## PRODUCT/PROCESS CHANGE NOTICE (PCN)

PCN #: **SR-0505-02**                      DATE: **8/3/2005**

Product Affected:   FPBGA 165 (BQ165) Package

**PCN Type:** Change in solder pad opening and ball diameter for FPBGA 165 (BQ165) package.

Example of FPBGA 165 Package Top Mark

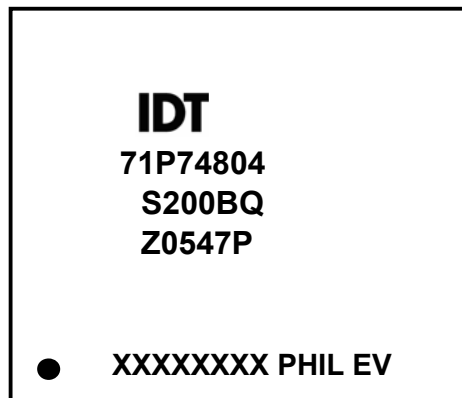
Encrypted assembly date code suffix on the assembly lot number

**XXXXXXXX** = Assembly Lot Number  
**PHIL** = Country of Origin  
**EV** = Assembly Date Code
